ECN/PCN No.: M1364

Product Description: Low Profile Shielded SMD Chip Power Inductor	Abrakon Part Number / Part Series: ASPI-0615FS Series	☐ Documentation only ☒ ECN ☐ EOL	☒ Series ☐ Part Number(s)
Affected Revision: E	New Revision: F	Application:	☐ Safety ☒ Non-Safety

6.0 Mechanical and Material

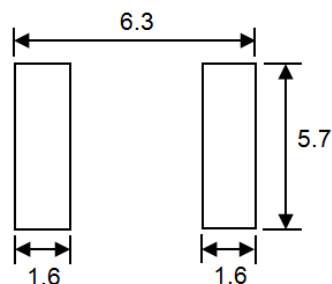
A	B	C	D Typ.
6.0 $\pm$ 0.2	6.0 $\pm$ 0.2	2.0 $\pm$ 0.2	1.50

8.0 Packing

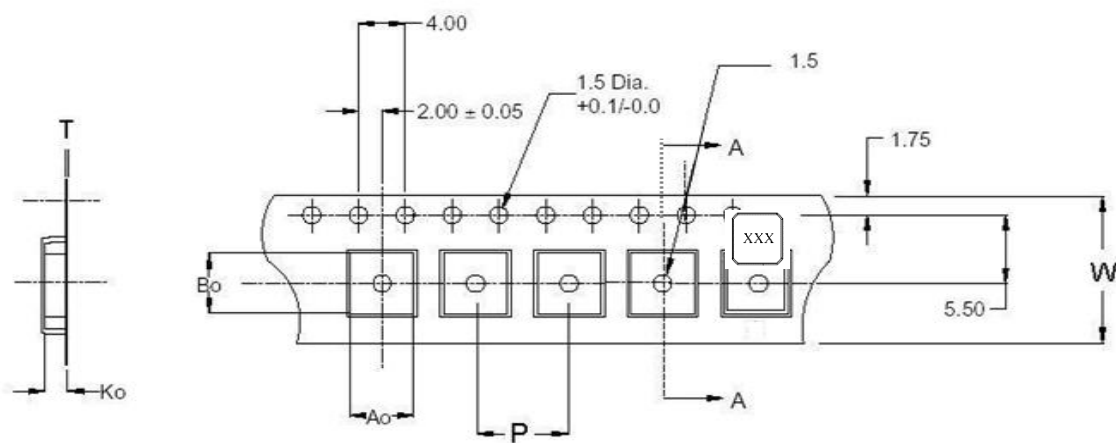
T2: 2,000pcs / reel

Ao	6.35
Bo	6.20
Ko	2.40
W	16.00
P	12.00
T	0.40

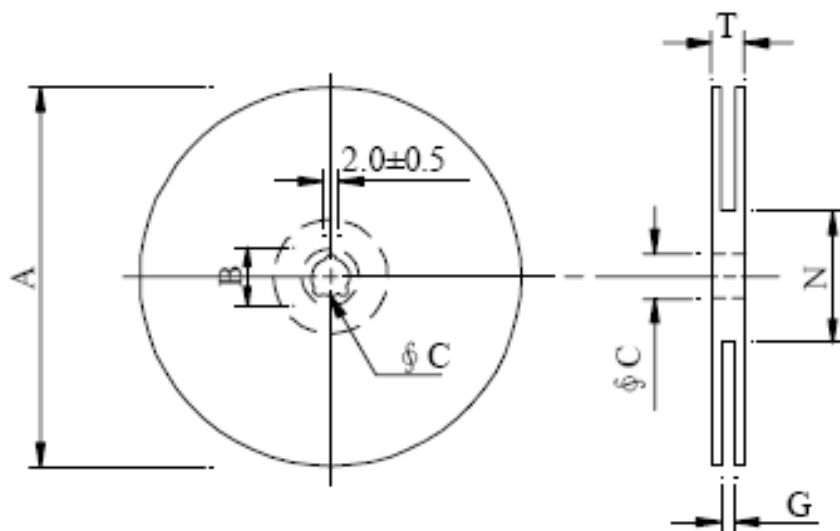
A	330
B	21.0 ± 0.8
C	13.5 ± 0.5
G	16.6
N	99.5
T	21

6.0 Mechanical and Materials

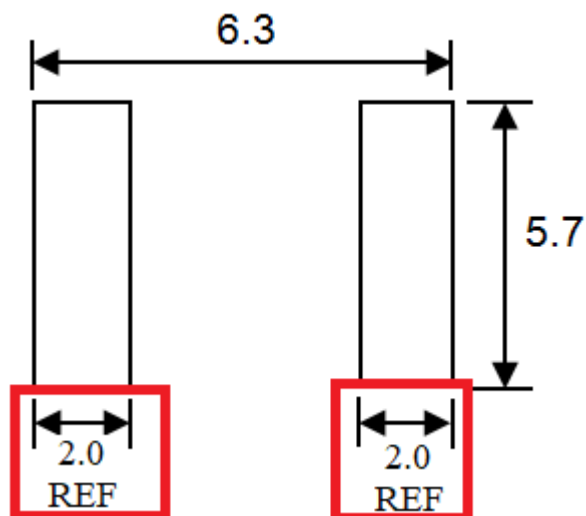
A	B	C	D Typ.
6.0±0.3	6.0±0.3	2.0 MAX	1.50

8.0 Packing

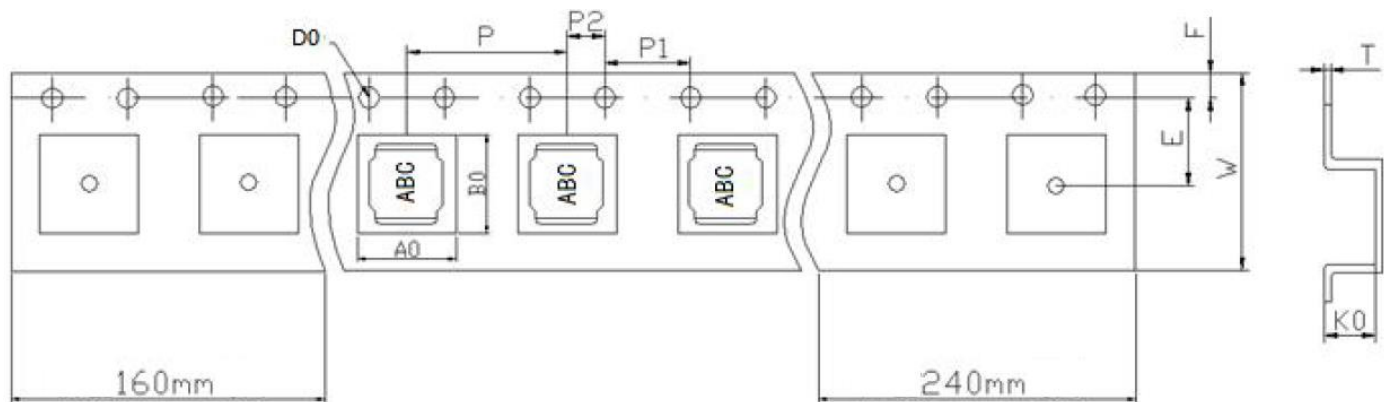
T2: 3,000pcs / reel

Dim	W	A0	B0	K0	P	E	F	D0	P0	P2	T
ASPI-0615FS	12.0±0.3	6.3±0.1	6.3±0.1	2.2±0.1	8.0±0.1	7.5±0.1	1.75±0.1	1.5±0.1	4.0±0.1	2.0±0.1	0.35±0.05

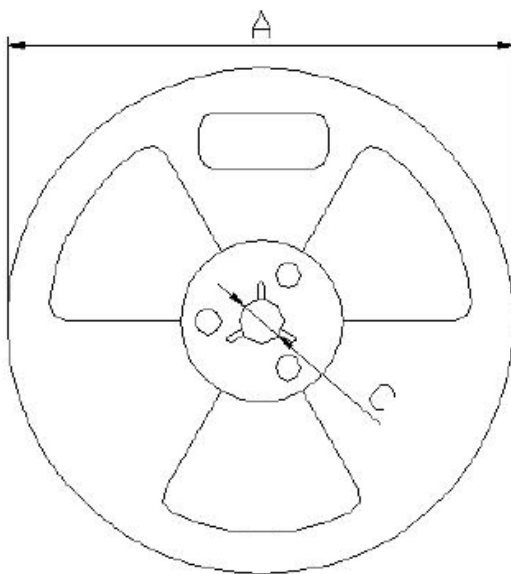
A	330±0.5
B	100±0.5
C	13.5±0.5
W	12.5±0.5
